Project: LFC Shower Renovations Buildings 1 and 2

Addendum #1.

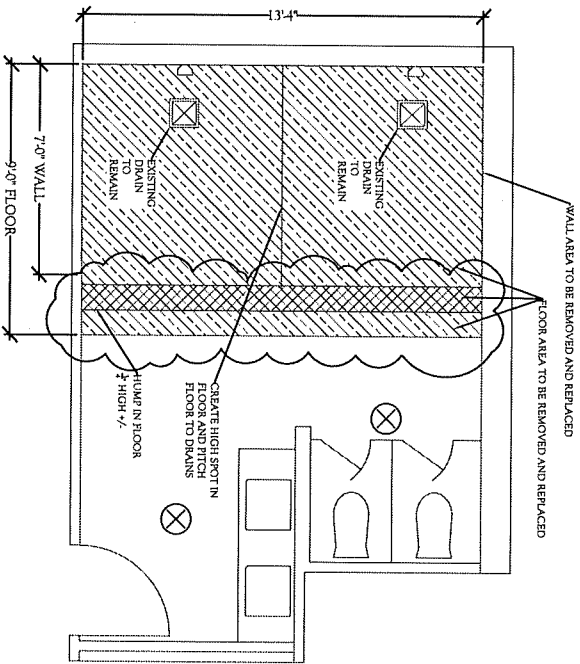
- 1) Sign-in sheet attached
- 2) Clarification bid is for 3 shower areas. Two in Building 1 (Apts. A &B)  
One in Building 2 (Apt. E)
- 3) Floor replacement will extend 9' (nine feet) out from back wall not 7' (seven feet)  
Wall replacement will remain as shown in original sketches. New sketches are attached showing revisions.
